Lot 18 WS - 23 Avents Creek Way, Fuquay- Varina, NC 27526

THE APEX - LH 'GEORGIAN'

Redlines Complete - 3 March- 24- DP

THE APEX - LH
First Floor Plan 'Georgian'

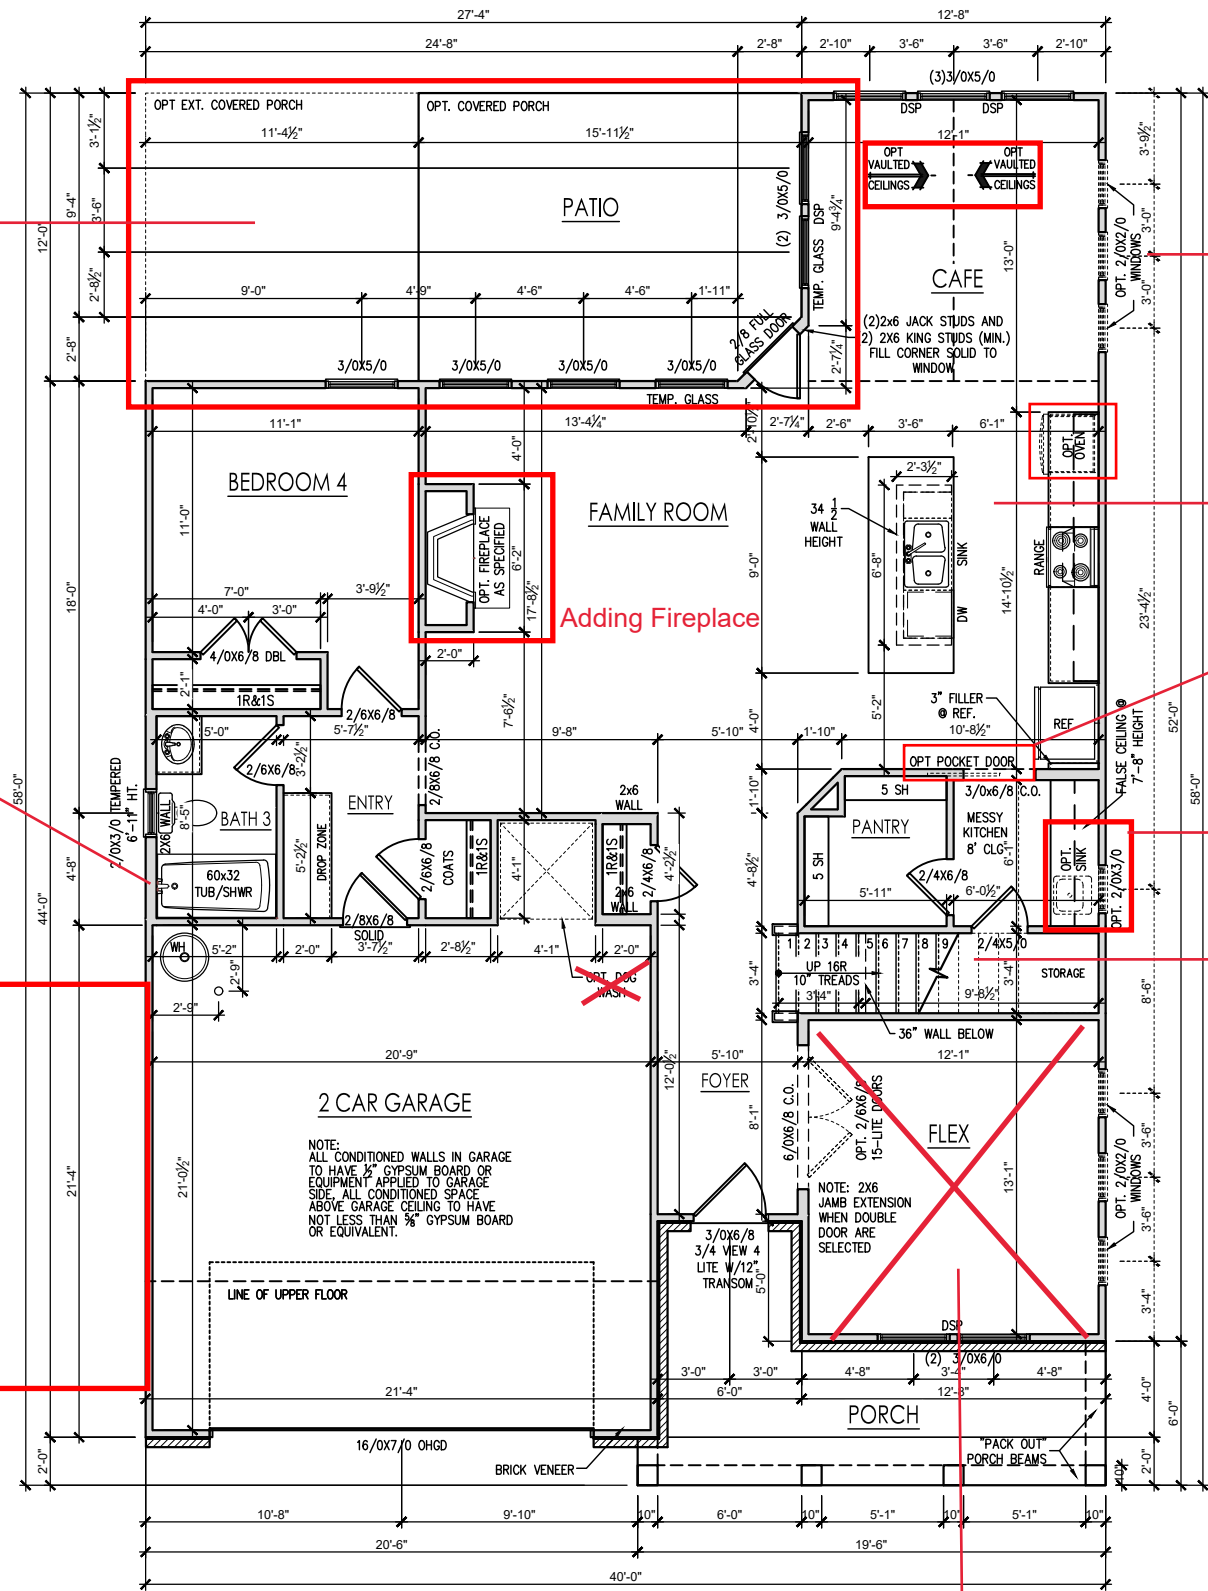
Shower ILO Tub/Shower

Adding (3) 2'x2' Windows in Cafe

Gourmet Kitchen

Pocket Door to Messy Kitchen

Adding Sink and Window at Messy Kitchen

Oak Treads

Second Floor Plan 'Georgian'

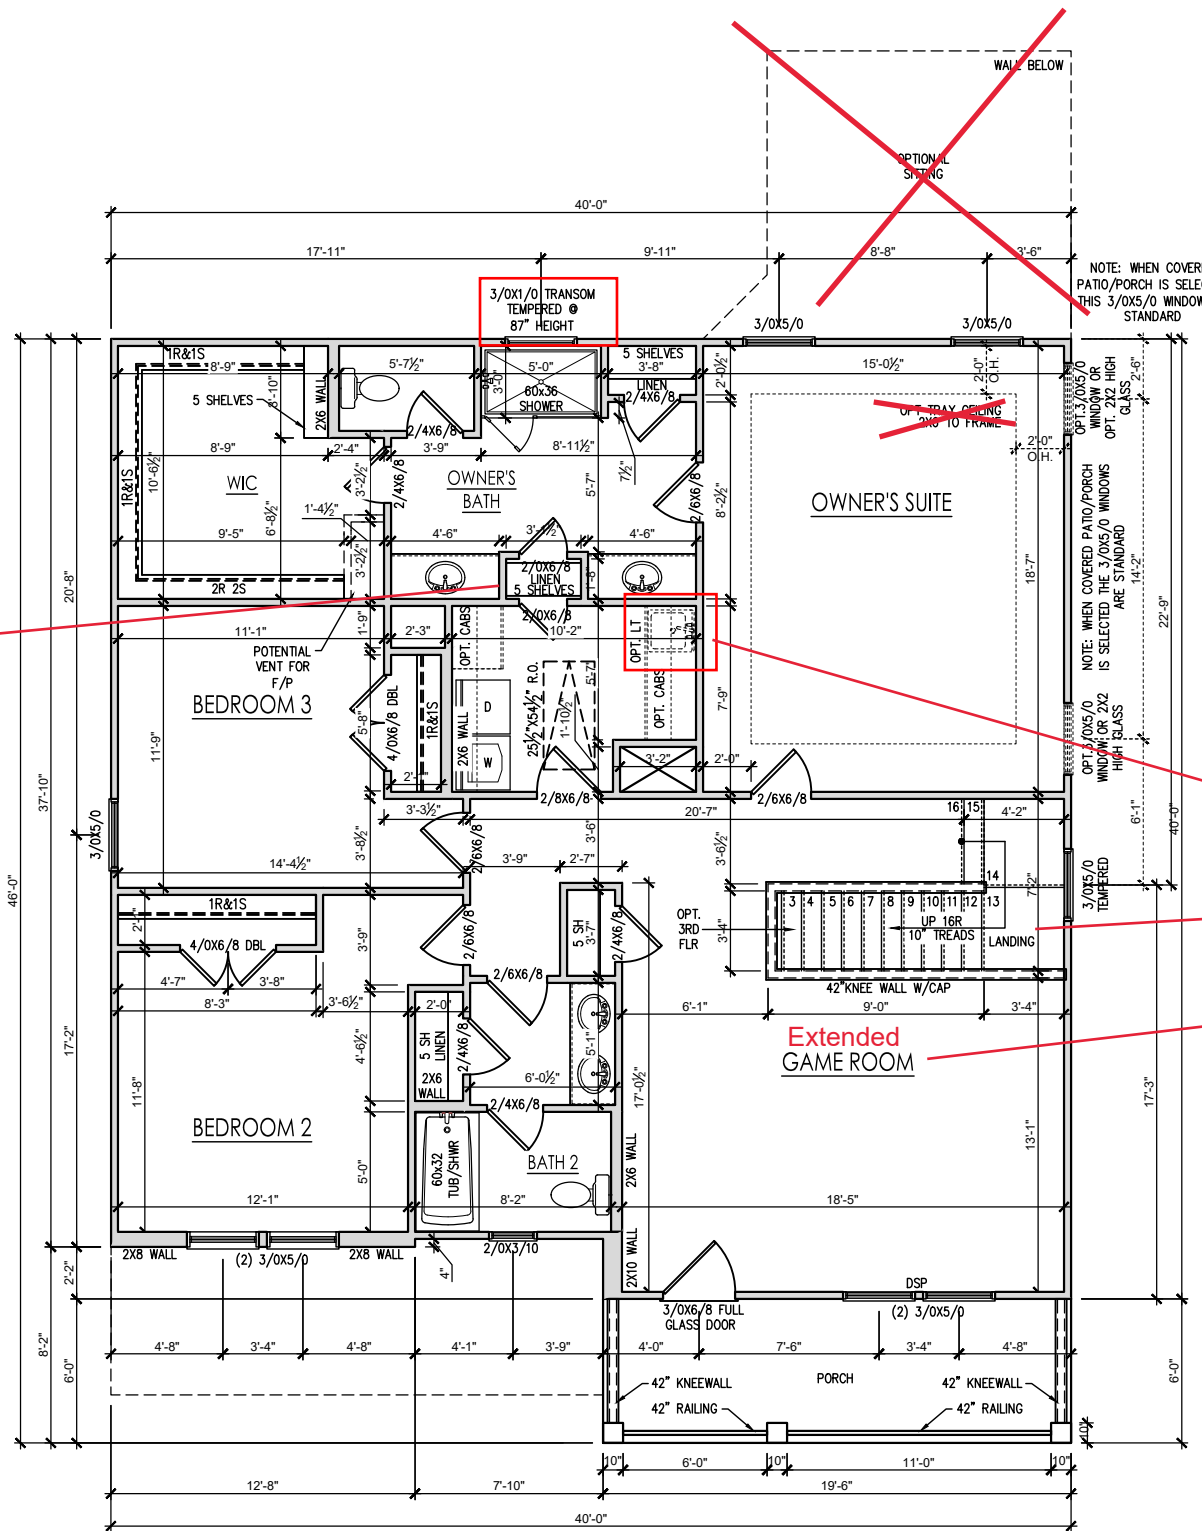
Wood Shelves at Owners Double Linen ←

→ Adding Laundry Sink

→ Oak Treads
